**INVESTIGATION WORK PLAN
BINGHAMTON REALTY
FORMER TRIPLE CITIES METAL FINISHING FACILITY
4 NOWLAN ROAD
HILLCREST, NEW YORK**

**January 2005
PROJECT NO. 99011A**

Re: Former Triple Cities Metal Finishing Facility, BCP Site No. C704045
Investigation Work Plan.

Geologic			
Geologic NY, Inc.			
PROPOSED SAMPLE LOCATIONS			
TRIPLE CITIES METAL FINISHING CORP.			
HILLCREST, NEW YORK			
DR. BY: SMC/SDW	SCALE: 1"=60'	PROJ. NO: 99011	
REV'D BY:	DATE: DEC. 2004	DRWG. NO: 3

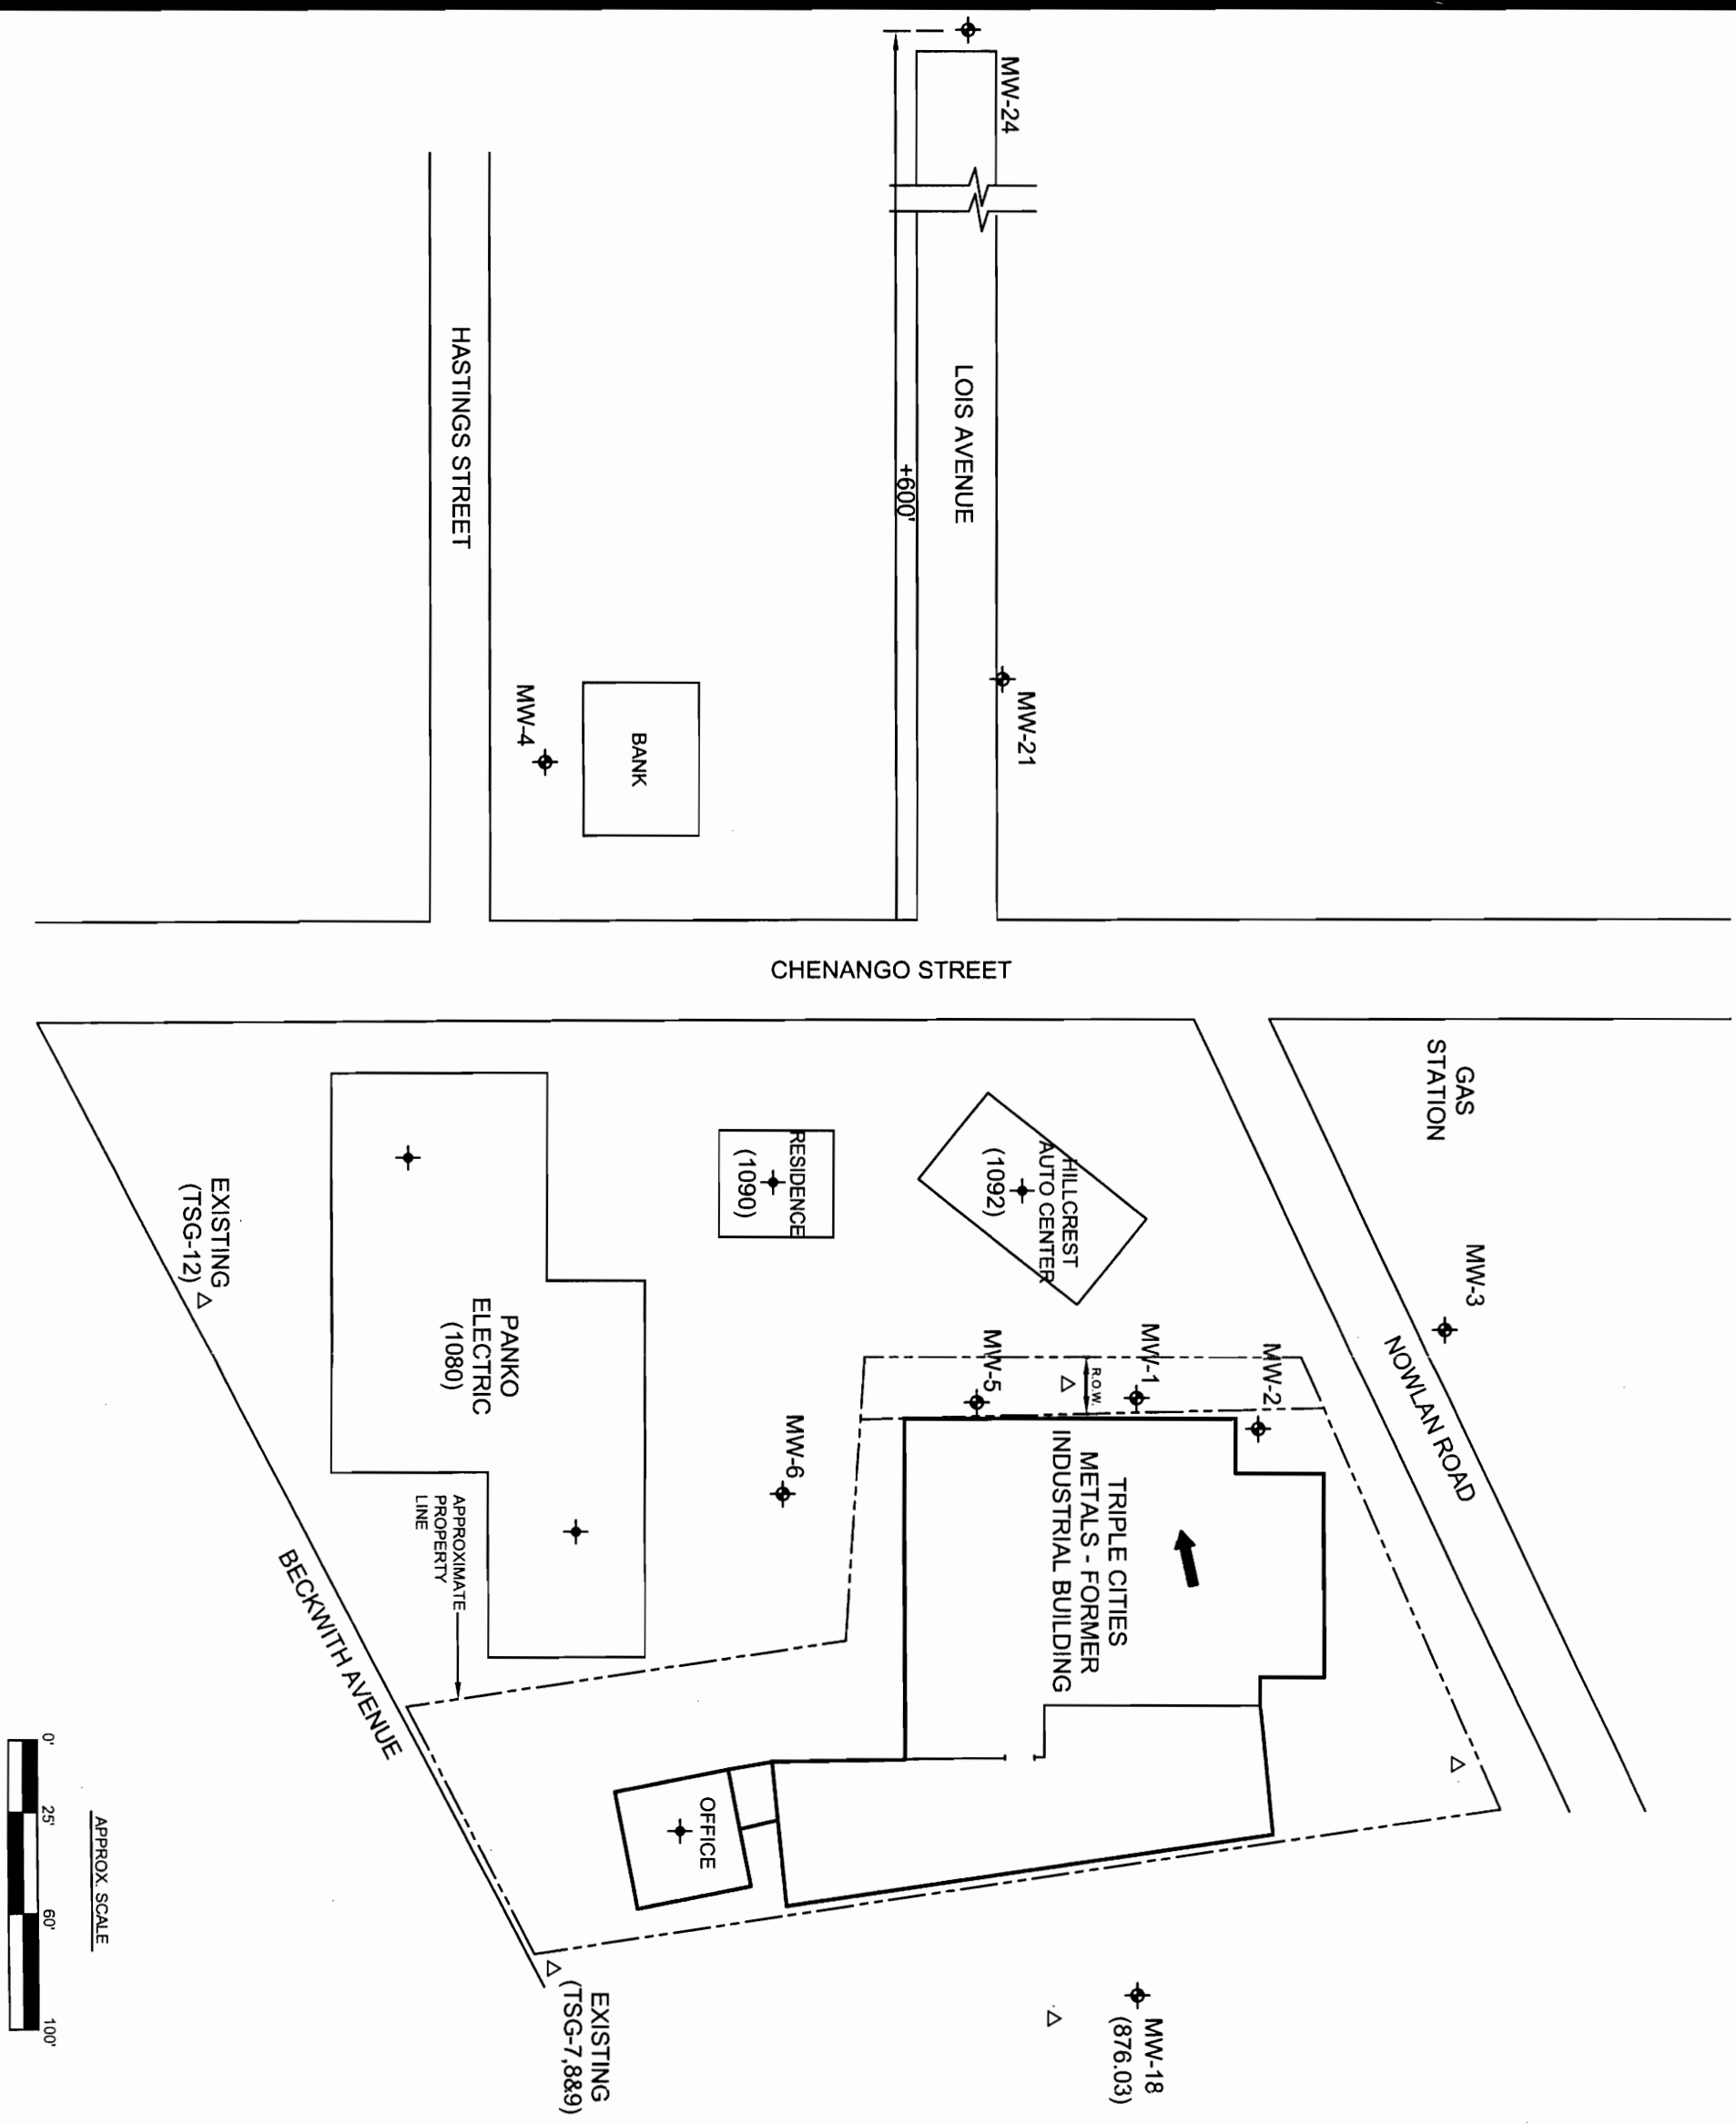
- Appendix B, Section 6.2-6.5 - A Generic Community Air Monitoring Plan (gCAMP) must be implemented during the proposed ground intrusive work. The Community Air Monitoring Plan presented in Appendix B should be revised to include all aspects of NYSDOH's gCAMP.
- Drawing No. 2 - please explain in the text of the work plan the purpose and/or activities occurring at boring location nos. 1-8 on this drawing. If they are not part of the proposed or past site investigations, they should be removed from this figure and legend.
- Drawing No. 3 - please clarify the site boundary on this drawing. It is unclear whether monitoring wells no. 1 and 5 and the proposed soil vapor cluster on the west side of the building are on site or off site.
